**ANGEL PLACE  
LEVEL 8, 123 PITT STREET  
SYDNEY NSW 2000**

## **PPSSNH-47: CLARIFICATION & ADDITIONAL INFORMATION**

We write on behalf of the Manly Warringah Sea Eagles as the applicant for DA2019/1190 to be heard before the Sydney North Planning Panel (Panel) on Wednesday 29 July 2020.

Table 1: Tree Incursions

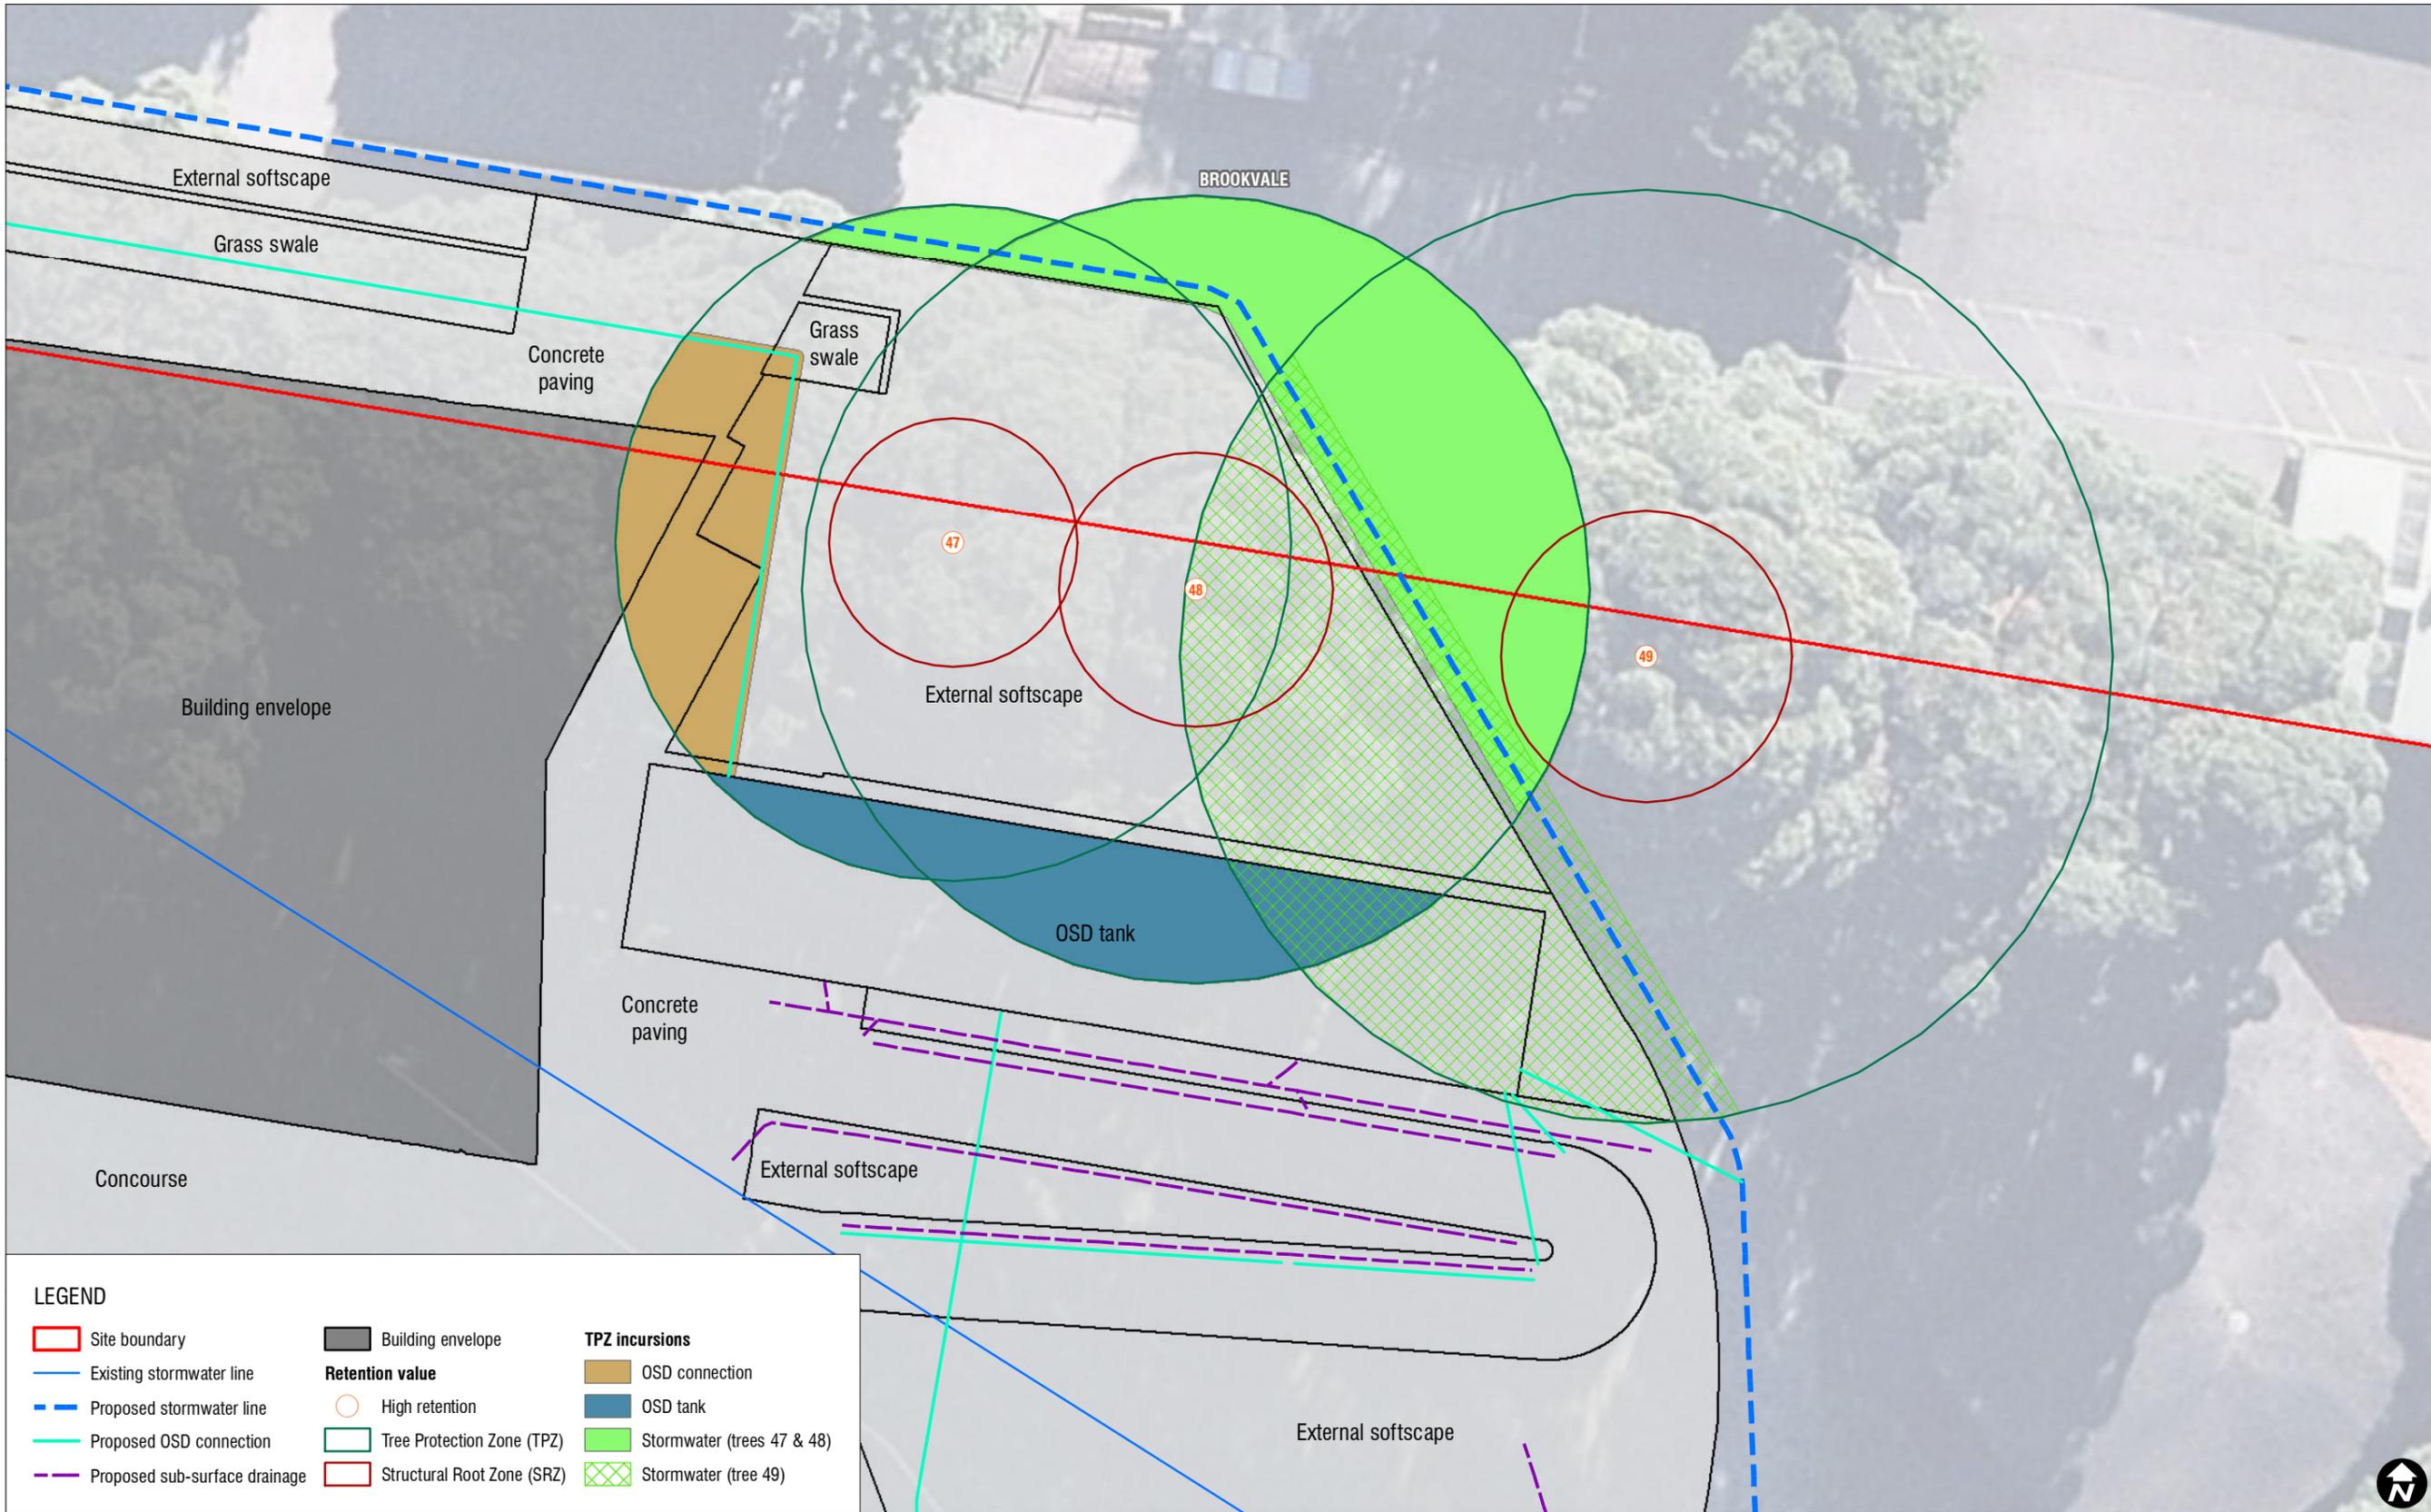
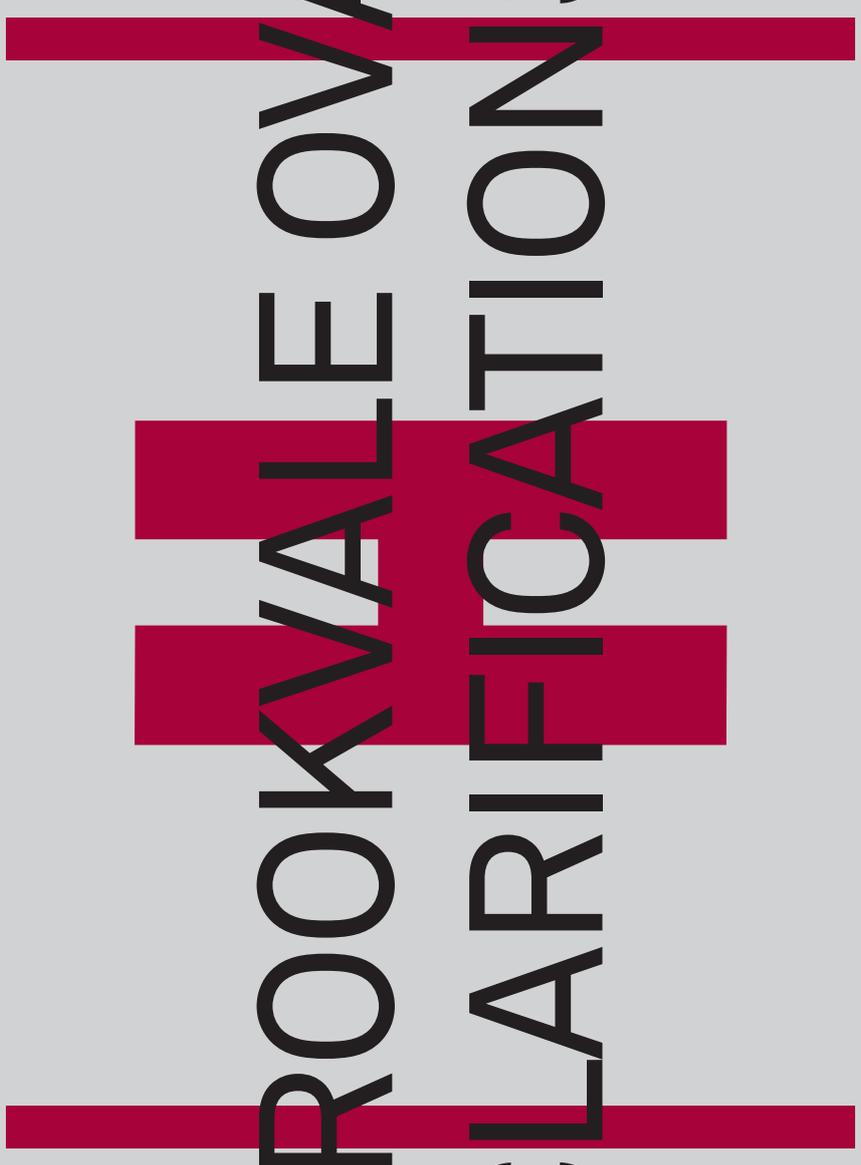
As shown in the revised Tree Impact Plan (Appendix 1) and Tree incursions (Table 1), the accumulative and additional tree impacts to the (TPZ) Tree Preservation Zones of Tree 47, 48 and 49 are considered Major and without re-design or sensitive construction methods would require further tree removals.

It is concluded that to bring the current major TPZ incursions of Tree 47, 48 and 49 to an acceptable level the storm water design must be either changed or the construction method must be installed via under-boring at a minimum depth of 600mm. This construction method would reduce the storm water impact to zero and leave the OSD impacts at an acceptable level considering project arborist involvement as per the Arboricultural assessment dated the 23-10-19.

# REVISED STRATEGY

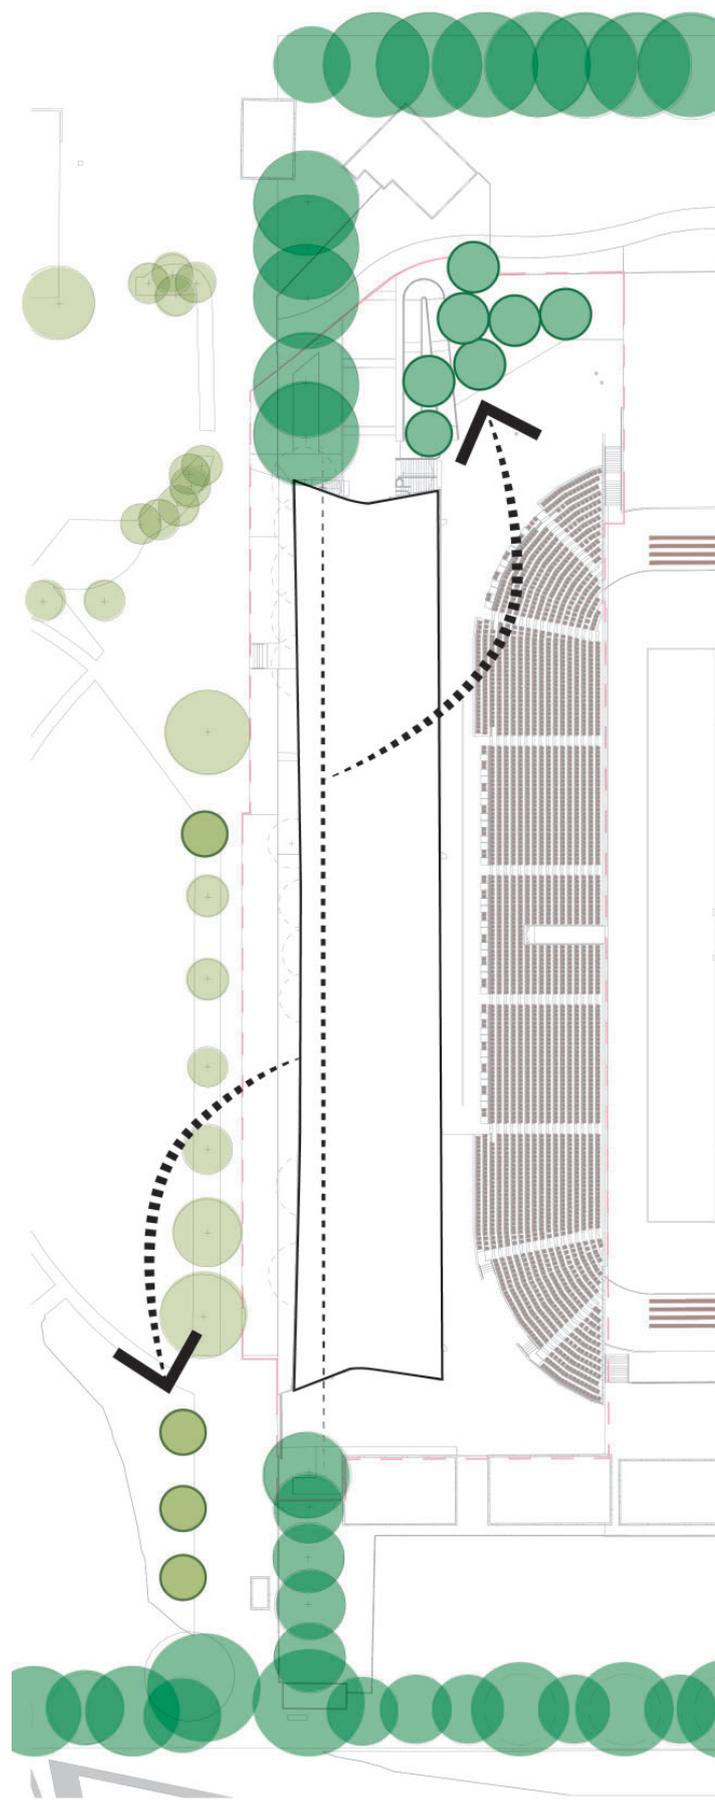
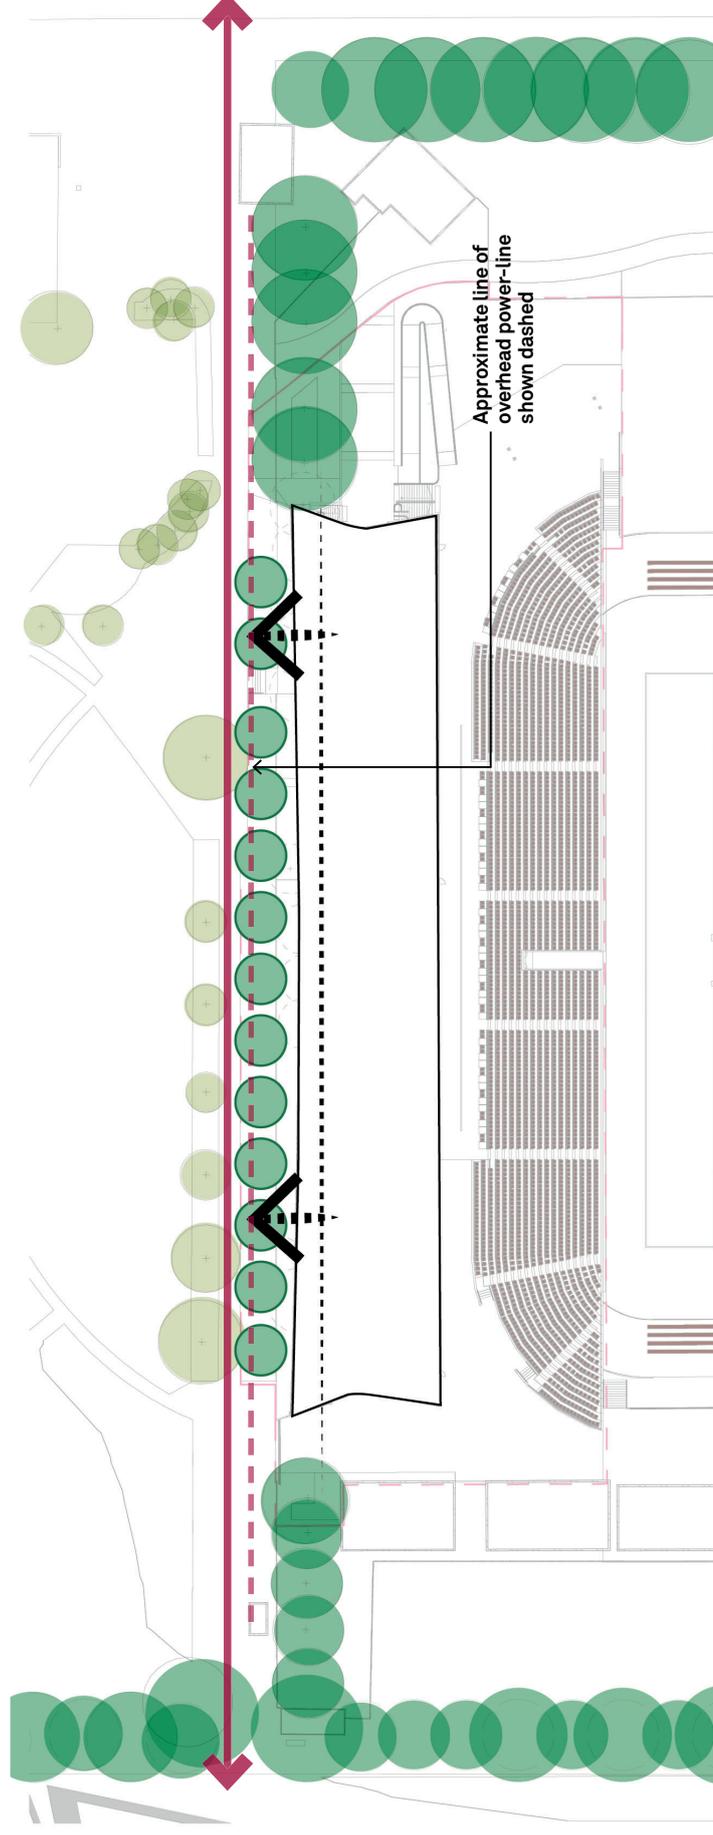
1. Page 15 to 19: Council's heritage officer has noted that the proposal seeks to offset the proposed removal of 11 heritage listed trees with 7 brush box trees and 4 tuckeroos. The assessment goes on to note, "*Turning to the proposed tree replacement planting option, it is considered to be a poor attempt to offset the loss of the heritage significant trees and is not acceptable. The proposed*

*location of the 7 new brush boxes is impacted and constricted by the pedestrian ramp/access area and proposed sewerage and stormwater lines."*

- As desired by Council re-establish the east-west avenue of trees and provide a landscape interface between park and CoE with a mix of **15x Banksia Aemula (Wallum Banksia) + Callistemon Citrinus (Red Bottlebrush)** at 6-7.5m centres located within the existing and new garden bed to the north of the new CoE site.  
(These species have been selected as they flower at the beginning of NRL season)
- Selected trees are from the AusGrid tree guides and similar to Northern Beaches Council tree guide for Banksia and Bottlebrush which are permissible to be planted below the existing overhead power lines.
